**ADDENDUM # 4****Renovation of Commons A**

WBA 21-034.01

**TO: All Bidders****DATE: 30 January 2023**

**Renovation of Commons Building A**  
**BID SET**  
Tuskegee University  
Benjamin F. Payton Drive, Tuskegee, AL 36088  
21-034.01

5 UNIT C1-M - POWER & AUXILIARY  
1/4" = 1'-0"

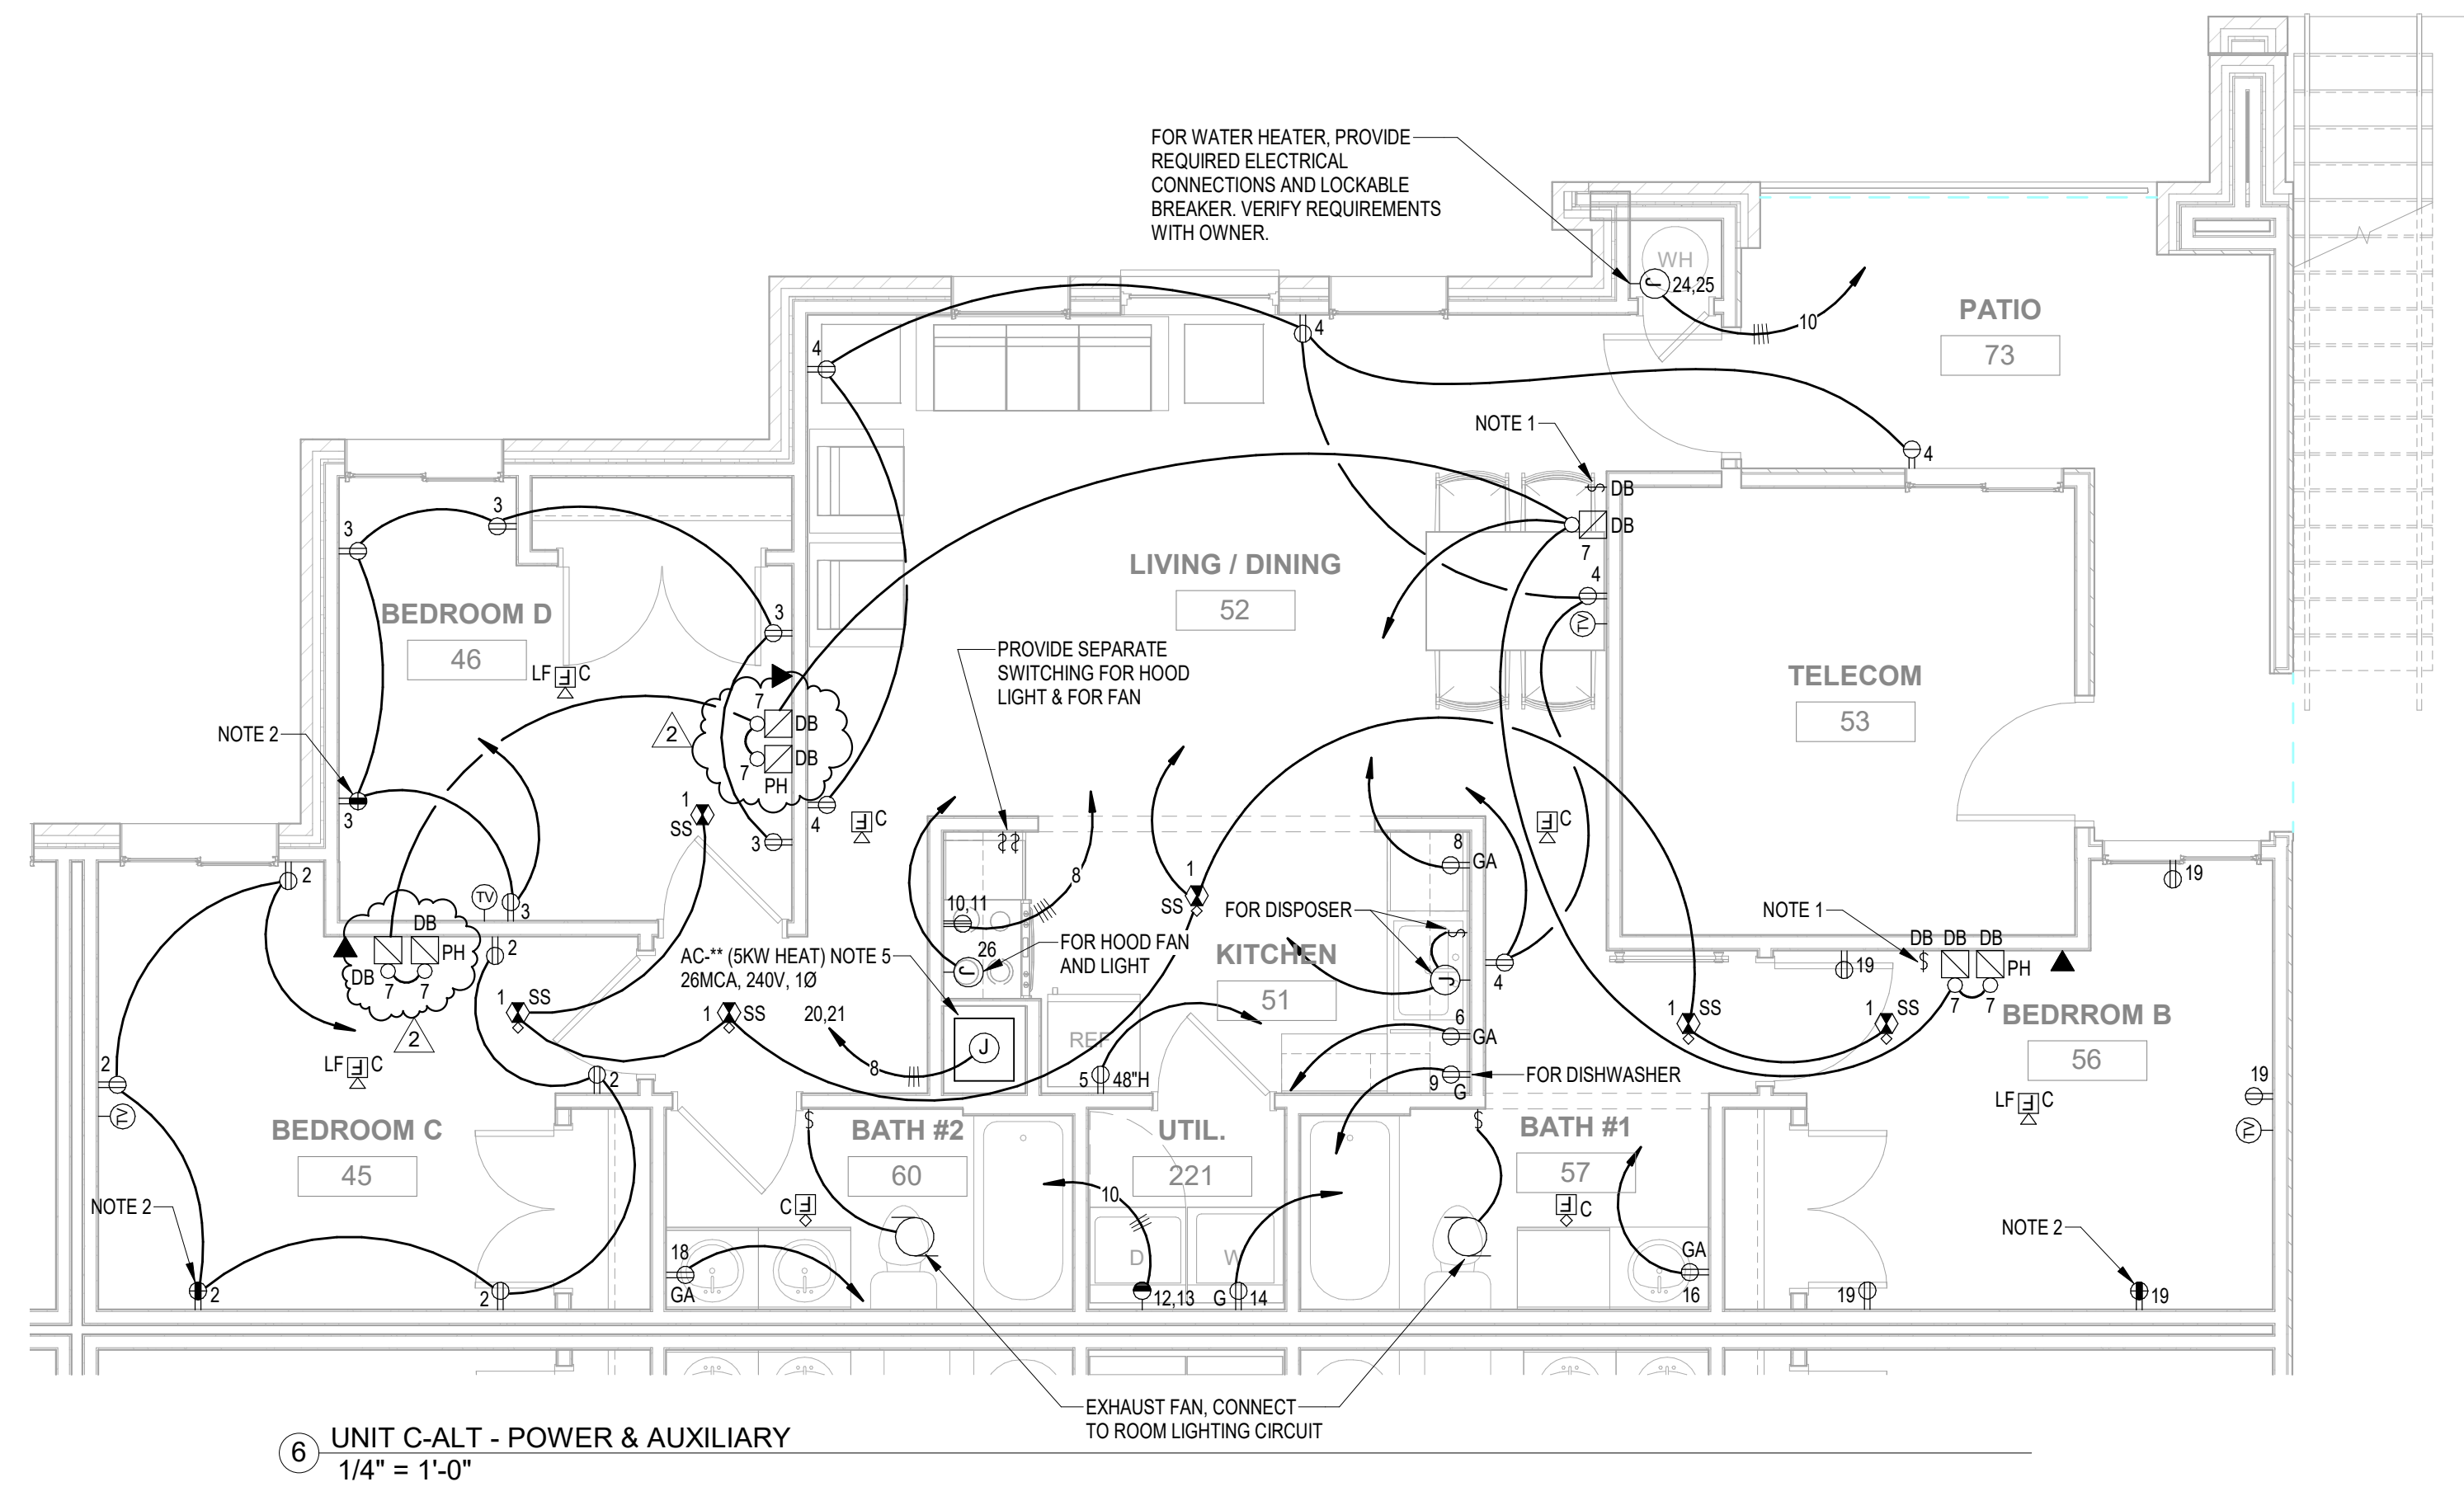
7. Sheet E5.2 – Revised device mounting heights to incorporate DCM review comments.
8. Sheets P001/P101/P102/P103 – North arrow and graphic scales were added, additionally riser diagram of the hot and cold water piping were added to incorporate DCM review comments.
